1. Context:

SOTON suggests replacing the 2-rods Invar configuration by a 4-rods Invar configuration in order to reduce observed high stresses in both the cage and the rods. The kinematics being similar, discussions are on going to understand how this limited design change affects the general design.

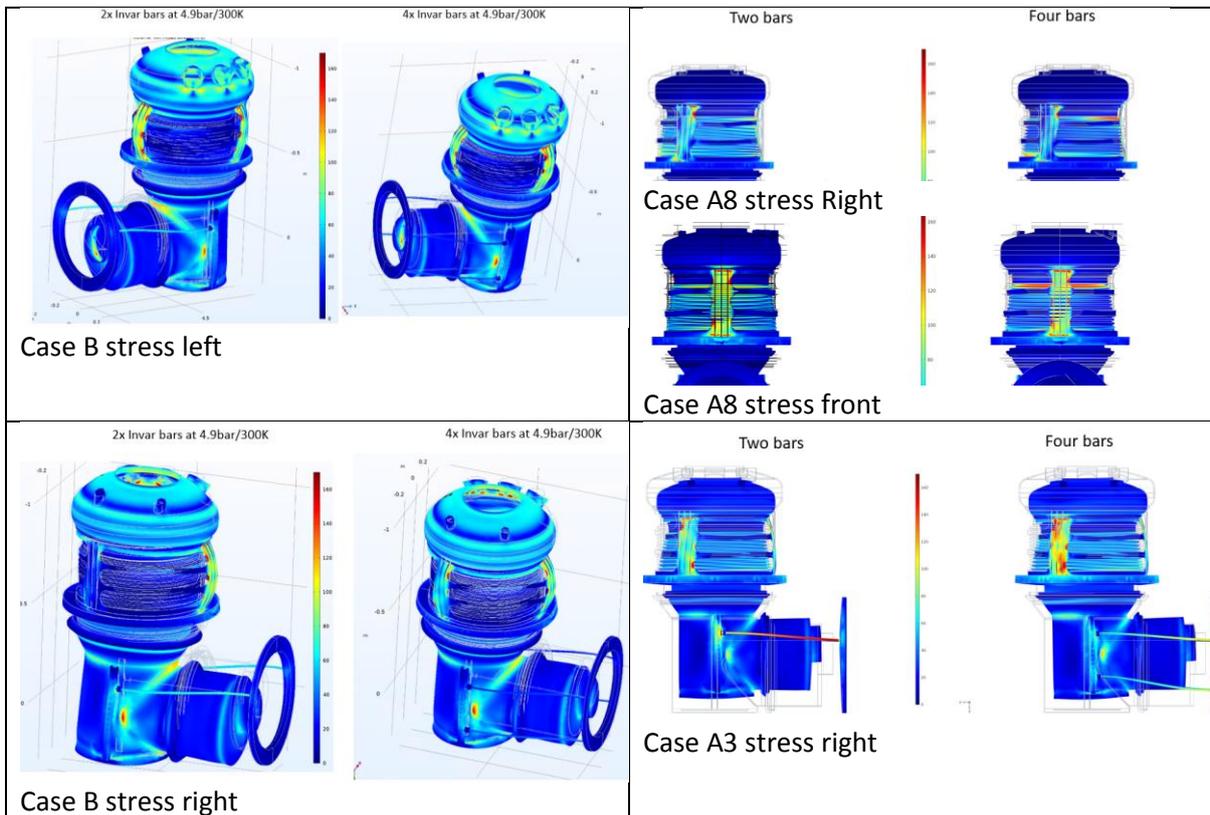
Calculations performed by SOTON show that the cage and the rods experience high stresses in the 2-rods configuration while are more reasonable in the 4-rods configuration, see illustrations from email 16.01.

Based on the observation of the stress distributions, the outcome is often comparable between the two configurations, which is reassuring as the kinematics is very similar. It appears that the 4 rods is not always presenting a safer stress distribution than the 2 rods, (ex Cases A8, Case A3 in cage) but in general the concern is located in the cage structure.

- The stress level in the pillar 2-rods of the Case B stress right is unexpected. Ansys performing the integral of the pressure applied on surfaces, the results should not change. However, maybe a surface is missing in the selection of applied pressure, this demonstrates the role of the 3-pillar orientation.
- It seems the displacement of the INVAR end attached to the Elbow is quite high compared to the order of magnitude

The high variations between simulations does not clearly identify the mechanical process brought by the 2 additional rods (why it relaxes or increases the stresses).

- The general stress level is (too?) close to the allowable limit → **add material ?**
- Calculations show the (too high?) importance of the 3 pillars orientation → **limit it by adding pillars ?**
- Rods stress level is high → **increase diameter ?**
